**SSD 9403 – 1-2 MURRAY  
ROSE AVENUE, SYDNEY  
OLYMPIC PARK**

**RESPONSE TO SUBMISSIONS**

Figure 1 – Wind Screening – West and East Elevation

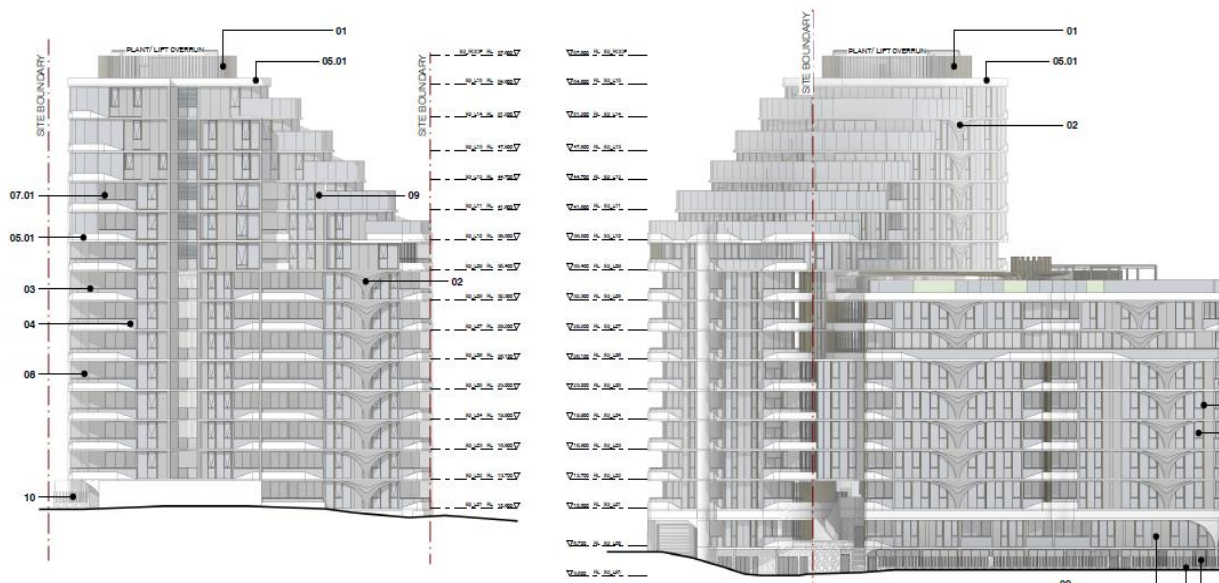
Issue	Comment	Response	Refer to
		<i>provide evidence of the pathway and scorecard to target 6 Star Green Star Design as Built Rating’.</i>	
3. Gross Floor Area	<p>The Wind Impact Assessment report identifies a need for 2.0m high impermeable screens to communal areas on Level 8 of Tower 2 and the large north and south-facing upper level balconies. If implemented, these screens result in the balconies and communal areas constituting additional gross floor area under the definition in the Standard Instrument.</p> <p>SOPA does not object in principle to the additional GFA that would be created by these screens but it should form part of the assessment of this application.</p>	<p>After careful consideration of the impact of wind on the amenity of residents as set out in the Windtec’s report the top floors of the development with large balconies have been redesigned to screen the wind throughout 2m high wind screen and in two units full height to the underside of balcony wind screen. Further consideration has also been given to including denser foliating vegetation to achieve suitable wind conditions. The numbering of the buildings has been included in the change to reflect other comments made.</p> <p>The revised plans are attached at Appendix A.</p>	Refer Appendix A.

- Balcony screening and wintergardens between levels 9-15 on site 1 and levels 8-15 on site 2;
- 2 accessible parking spaces within basement levels B1 and B2 of 1 and 2 Murray Rose Avenue.;
- Street numbers to be included on the south and North elevations of sites 1 and 2;
- An updated GFA schedule to outline the impact stemming from item 1 above; and
- Revised roof landscape layout.
